Access Compliance Report

Public Rights-of-Way

(Curb Ramps)

Intersection ID: 8157	Main Street: N_TRYON_ST	Cross Street: ORR_RD	Location: SW
ADA ID: 2DBCC1F0F6DD	Ramp Type: Perp	Initial Pass/Fail: Pass	Overall Compliance: No
Severity Score: 0			
Codes/Mitigation Info/Possible Solution		Field Measurements/Component Compliance

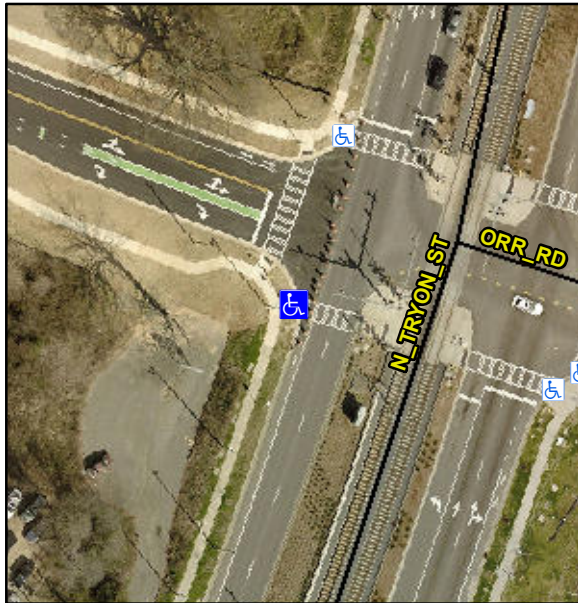
Remove & Replace Detectable Warning System.

R305.2
